ARKANSAS POWER & LIGHT COMPANY

SUBJECT: Arkansas Nuclear One - Unit 2

Docket No. 50-368
License No. NPF-6
ICC Monitoring System
Installation-NUREG-0737 Item II.F.2

Figure 1 - ANO - 2 ICC DETECTOR LOCATIONS

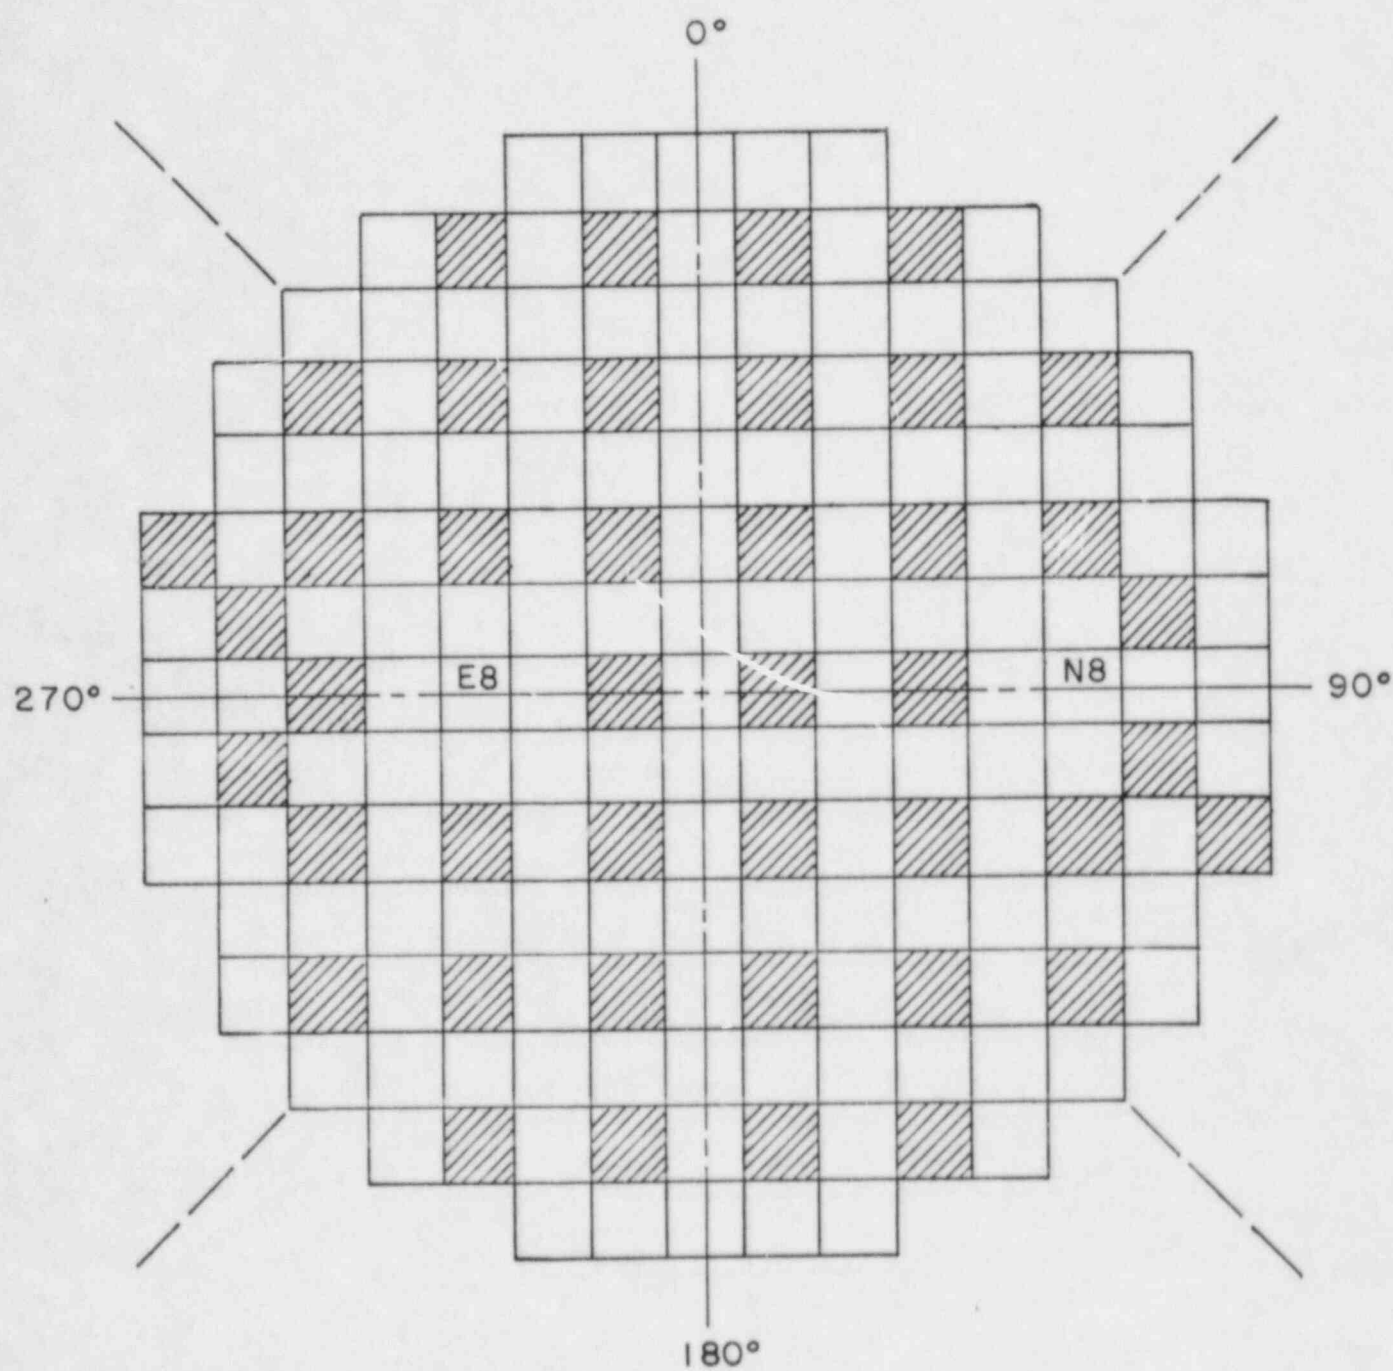
AP&L had intended to cut four sets of slots in two in-core instrument guide tubes (core map locations E-8 and N-8 as shown in Figure 1). As shown in details A, B and C of Figure 2, the slots below the isolator provide a path for steam to escape the tube so that voids created in the tube or which enter the tube below the isolator are purged from the tube. These vents therefore minimize the amount of frothing in the upper tube region, thus improving the efficiency of the guide tube for collapsed level measurement.

Figure 2 - DETAIL C

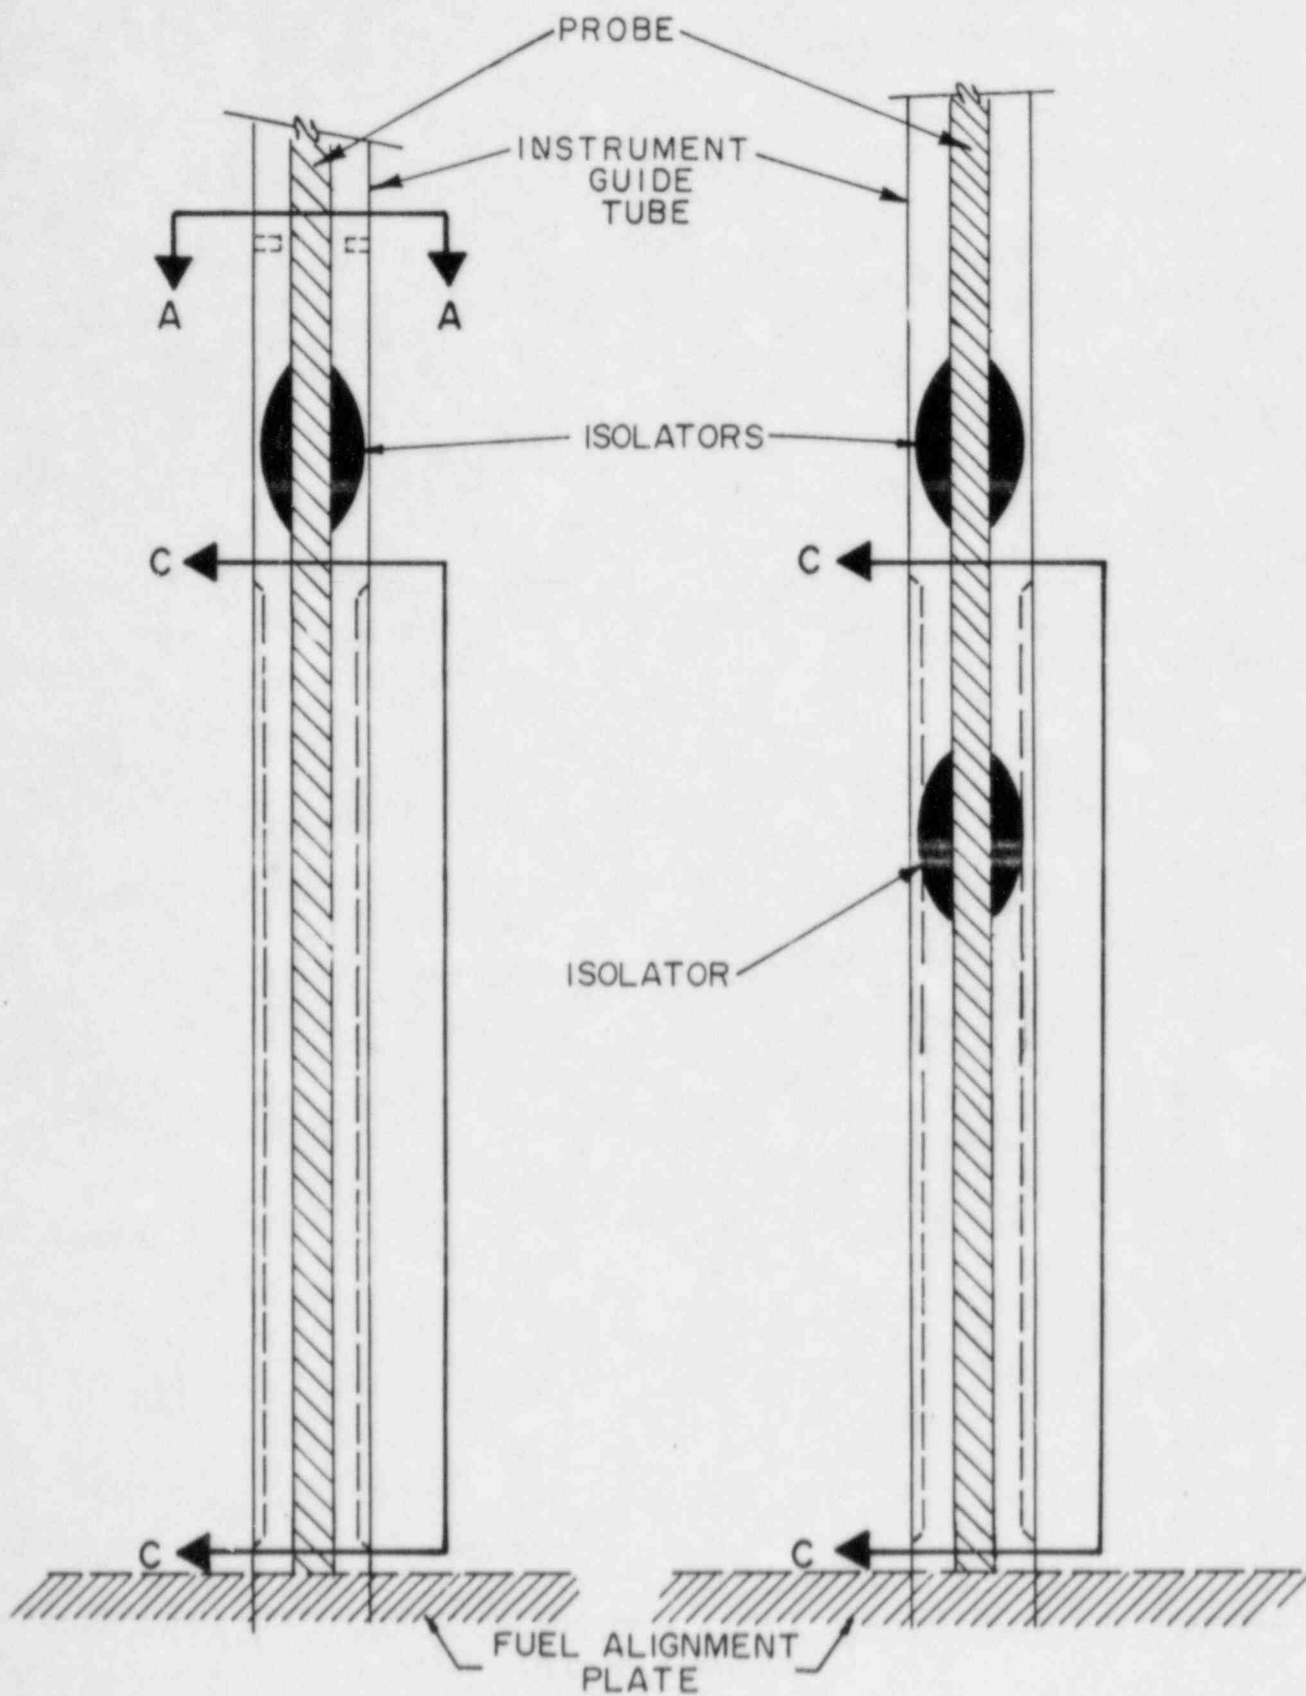
The existing slots in the in-core instrument guide tube, as shown in detail C of Figure 2, are five inches long and are located just above the fuel alignment plate. The gamma thermometer probes were modified to locate an additional isolator on the probe approximately one inch below the top of the slots so that the single slot, which was to serve only as a purge vent, would now provide both upper and lower porting at the fuel alignment plate. This porting along with an existing gap in the guide tube near the vessel head, as shown in detail A of Figure 2, provide the desired manometer effect from the fuel alignment plate to the dome of the reactor vessel. This design will not, however, provide the segmentation of the manometer which allows separate collapsed level measurements in the plenum and dome regions.
